Draft amendments to unique AEBS regulation in order to create 01 series of amendments

I. Proposal

Arrangements of approval marks

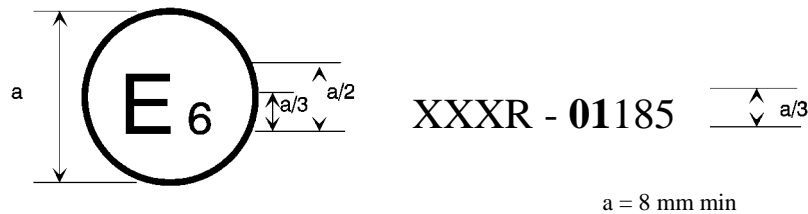
Annex 2, amend to read:

The above approval mark affixed to a vehicle shows that the vehicle type concerned has been approved in Belgium (E6) with regard to the AEBS pursuant to Regulation No. XXX. The first two digits of the approval number indicate that the approval was granted in accordance with the requirements of **the 01 Series of Amendments to the Regulation No. XXX in its original form.**
